Stage 3 acoustic design considerations.

This document sets out the key acoustic design items identified during coordination meetings with the Architect, to be further developed at Stage 4 once technical design of the final accepted refurbishment works begins.

1. Scope of proposed refurbishment works.

Figure 2 Screenshot of the Main Events Space acoustic model

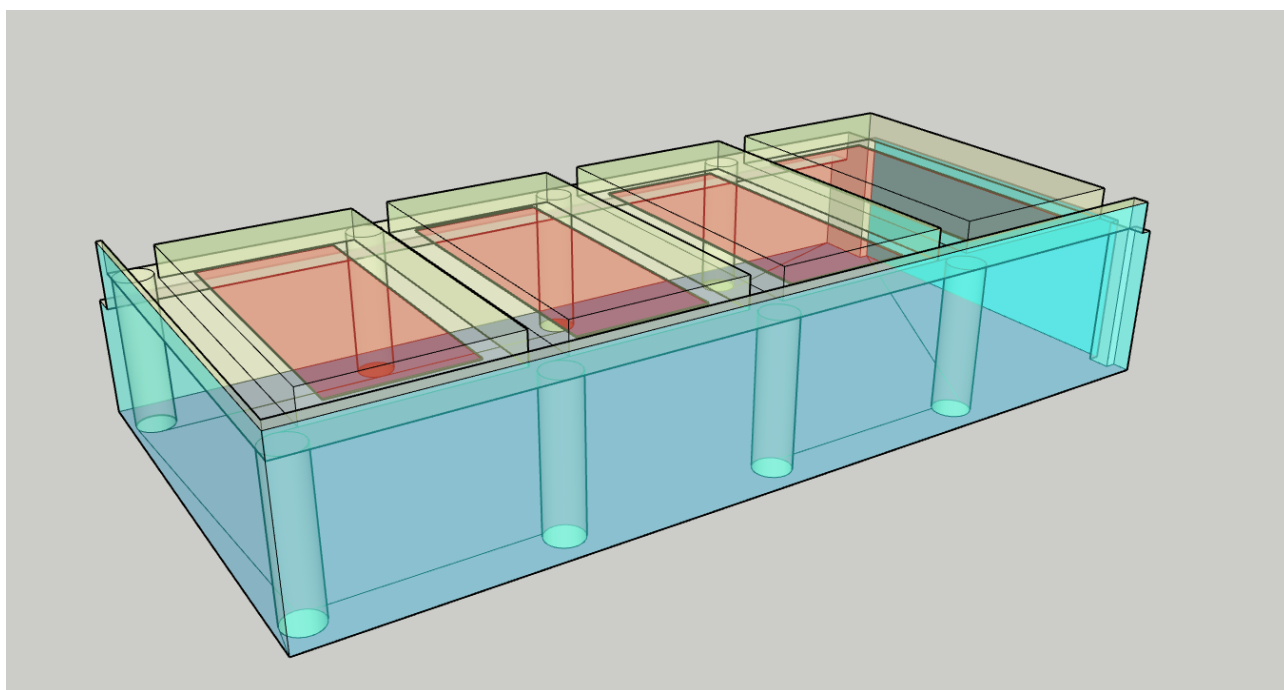
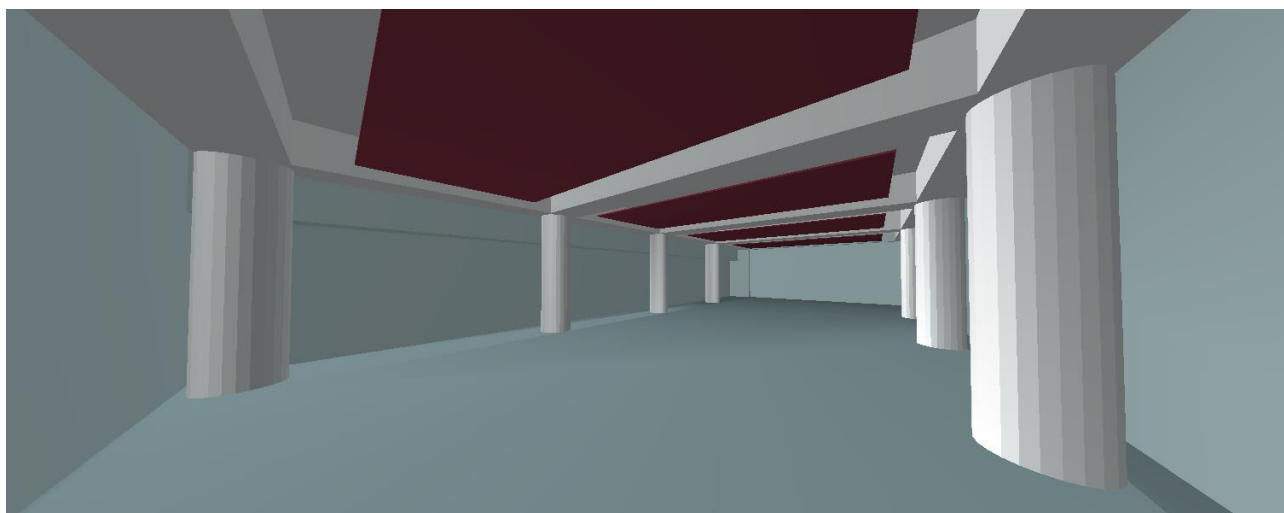
It is understood from a review of the Stage 3 Architectural package received for review on 14/04/2023 that 4no rafts comprised of 21 900x900 perforated metal tiles are proposed within the ceiling coffers across the room.

A 3D acoustic model of the Main Events Space has been created using the acoustic simulation software package Odeon to investigate the required finishes to provide suitable room acoustics within the space. A screenshot of the modelled geometry, as retrieved from the Stage 3 architectural package, is provided in Figure 1. A screenshot of the acoustic model is provided in Figure 2. While the preliminary and indicative furnishing scheme within the Architects drawings has not been modelled, a nominal allowance for the effect of furniture breaking up lateral reflections across the space has been taken into account in the modelling exercise carried out.

The results of the modelling exercise indicate compliance with the recommended project criteria would be achieved on the basis of the above strategy. Class A absorption is not considered to be an onerous performance to achieve from perforated metal panels with acoustic backing, subject to a sufficient free area being provided through the perforations.

It is recommended that tiles with acoustic backing be distributed as evenly as possible across each “raft”.

Figure 3 Marked-up extract of combined services layout drawing 0406115-HLEA-ZZ-50A-D60-CS-30-01

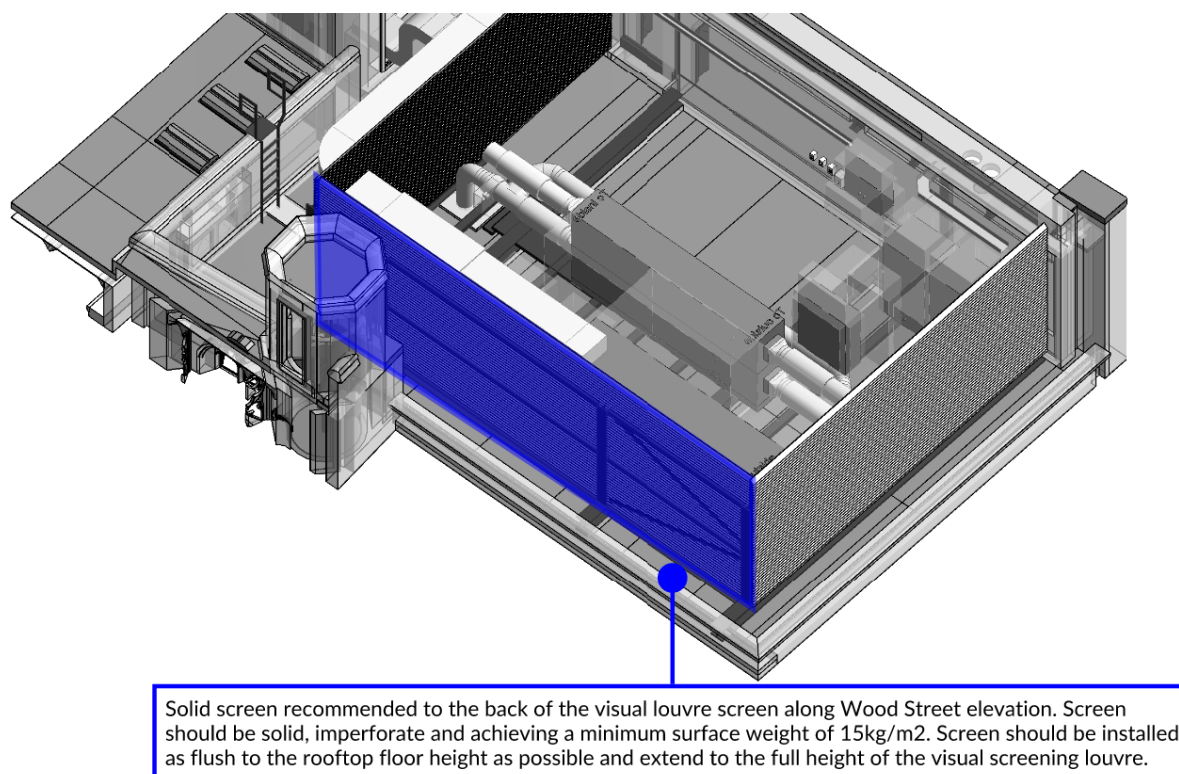
The results of an assessment of the proposed rooftop building services plant scheme show that a noise mitigation strategy shall be required in order to comply with the limits set in Table 2. These shall include, but not be limited to, the measures set out in Table 3.

A marked-up combined services layout is provided at the end of this note to illustrate the required extent of the solid screen recommended below is presented in Figure 1.

Plant item	Mitigation steps recommended
AHU01 & AHU02 atmospheric terminations	In-duct attenuation to be provided to all atmospheric terminations ensuring each termination does not exceed L_w 65 dB at the termination grille.
AHU01 & AHU02 casing break-out ^[1] All outdoor VRF units	Solid screening is recommended behind the proposed visual screening louvre proposed to the northern perimeter of the proposed rooftop plant area, to provide a solid imperforate barrier between the proposed and existing building services scheme and the nearest residences across Wood Street. The screen should achieve a minimum surface weight of 15kg/m ² and extend to the full height of the visual screening louvre enclosing the rooftop plant area.

The above measures are shown to result in a cumulative plant noise contribution of L_{Aeq} 37 dB at the front windows of the top residential flats directly across Wood Street from the proposed site, which complies with the limits set.

Figure 4 Marked-up extract of combined services layout drawing 0406115-HLEA-ZZ-50A-D60-CS-30-01

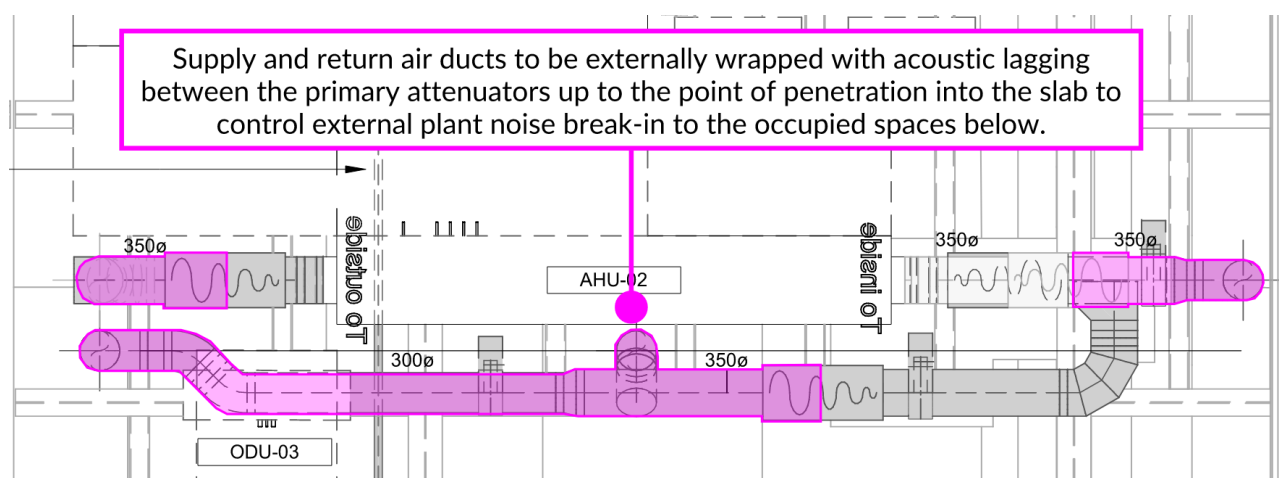
Where ductwork routes drop directly from the rooftop plant area to the third floor, there is a risk that rooftop plant area noise could transfer down into the occupied spaces below.

As such, it is recommended that an allowance be made at this stage to provide a minimum of 25mm external acoustic lagging (comprising an internal mass element with surface weight of 5kg/m²). The identified routes where this occurs are shown in Figure 4. The external lagging should extend from the primary AHU-side attenuator to the point of penetration through the rooftop slab.
